SYAMA PRASAD MOOKERJEE PORT,KOLKATA
Erstwhile KOLKATA PORT TRUST
HALDIA DOCK COMPLEX

Tender No. SDM (P&E)/T/ 62 /2019-2020

Supply, Installation, Testing and Commissioning of 11kV/3.3kV/415V Panel along with allied works for augmentation of GC Berth Sub-station including construction of sub-station building at GC Berth area of Haldia Dock Complex, SMP, Kolkata.

ADDENDUM - IV

ROOF PLAN

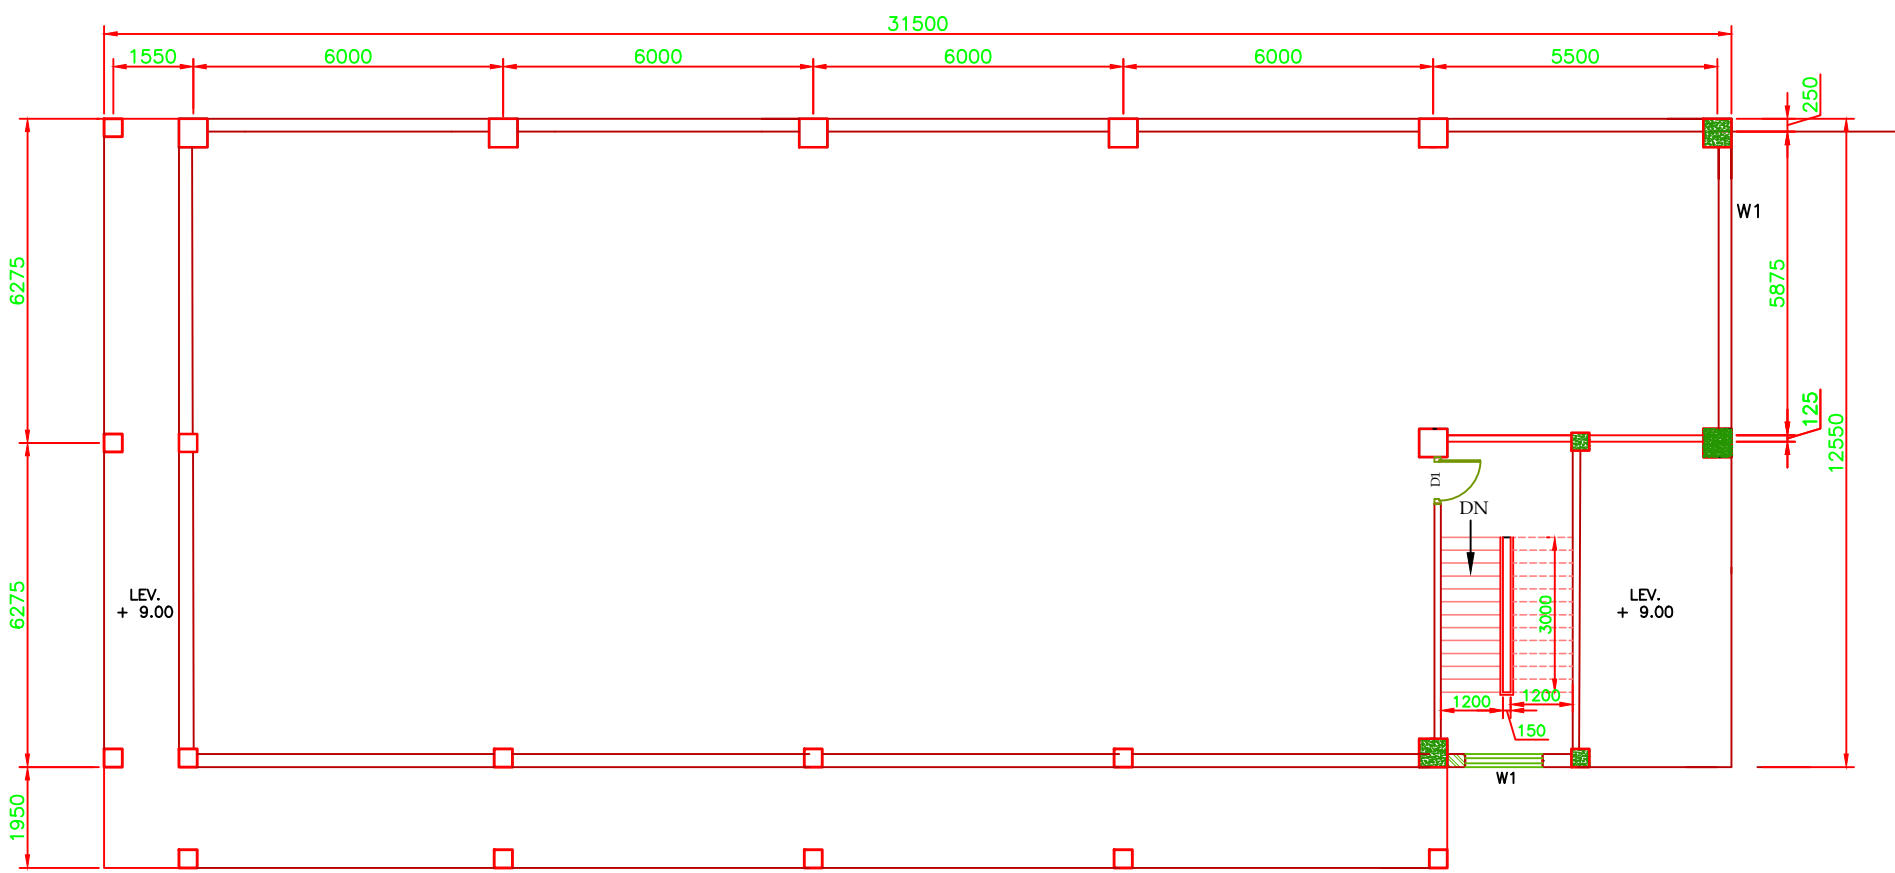
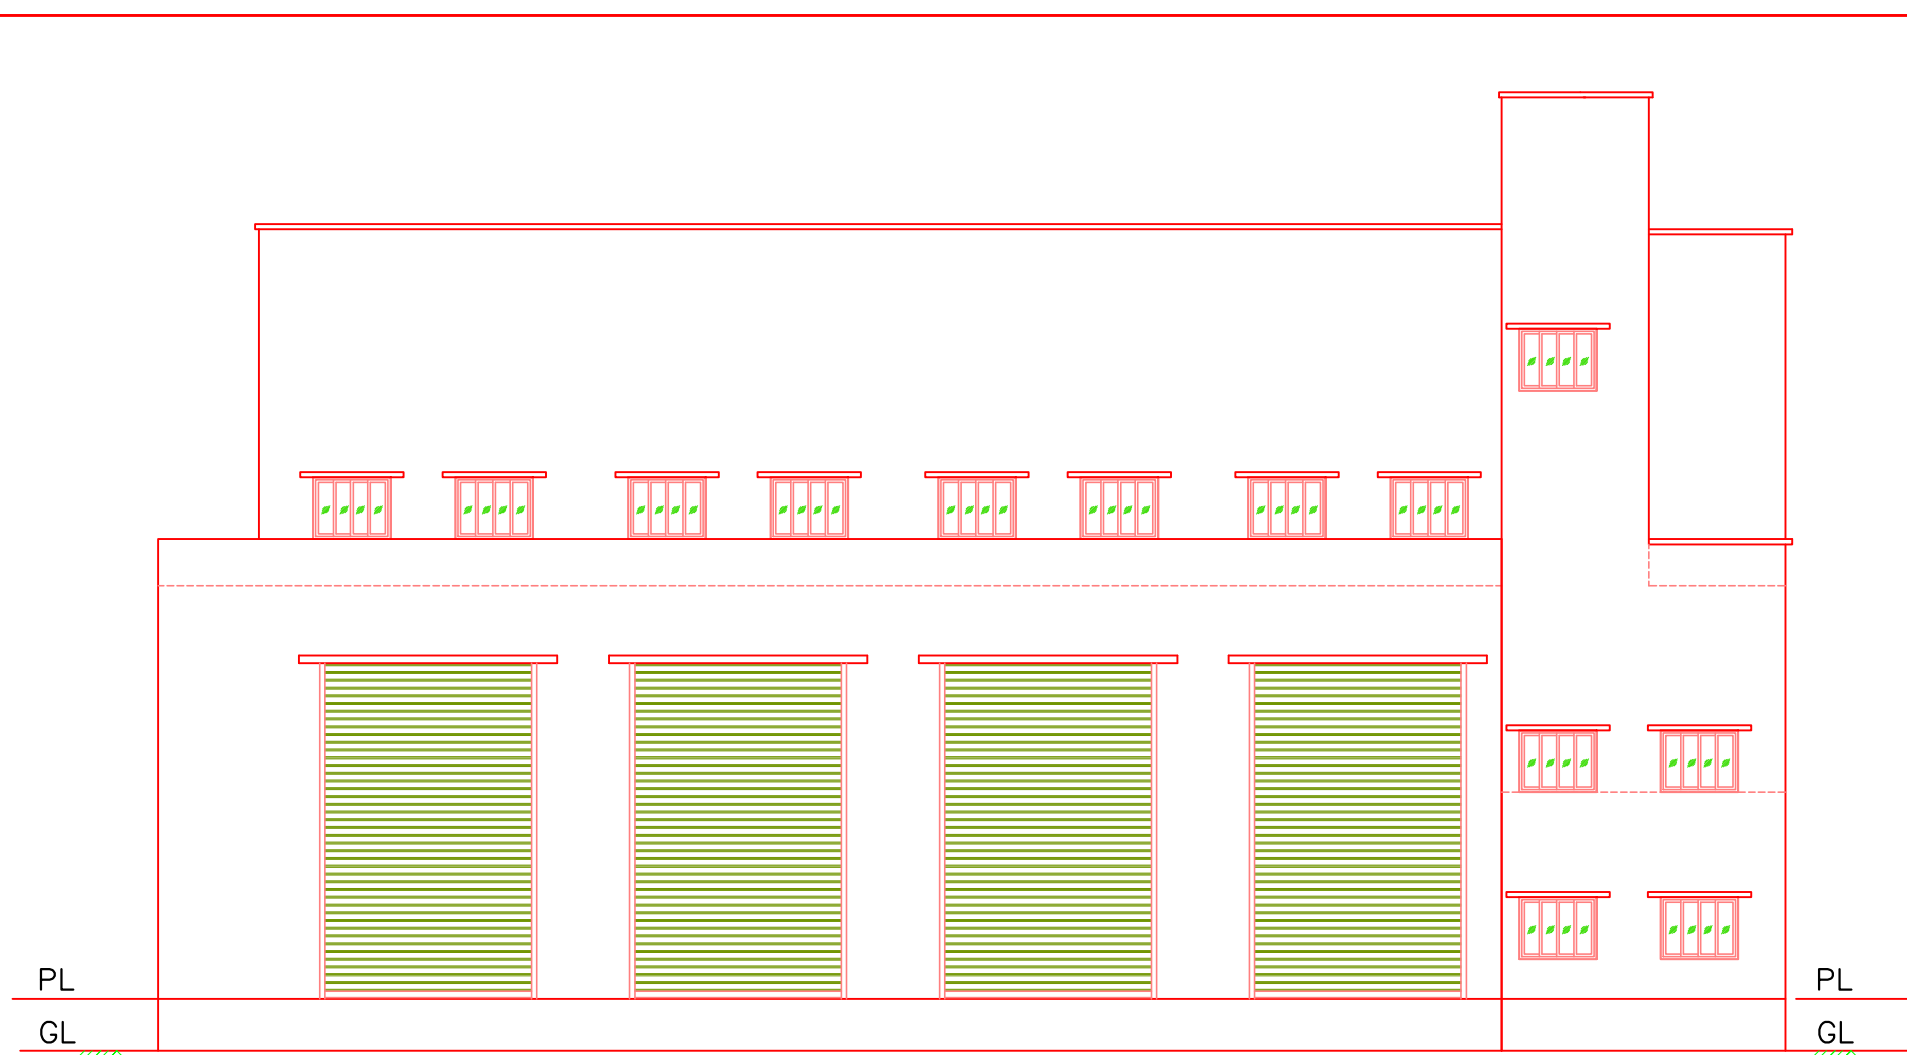
3.	155	Part B Wiring and electrification of sub-station. Item No.1	Building dimension (35x12x8) Mtrs. Ground floor (35x12x6) Mtrs.1 st Floor	Building dimension (31.5 x 14.5 x 8) Mtrs. -Ground floor (31.5 x 14.5 x 6) Mtrs.-1 st Floor

13.	Drawings	Please provide the SLD for HT & LT Panels.	Please see addendum.
14.		In BOQ Building dimension (35x12x8) Mtrs Ground floor (35x12x6) Mtrs. 1st Floor is given. But in drawing ground	Please see addendum

Sl. No.	Reference	Queries of the firms	HDC, SMP's Clarifications
		floor, 1st floor (8mtr-Height) & Hall room (9mtr-Height) is mentioned. Please provide us Civil & Structural work drawing for Substation building.
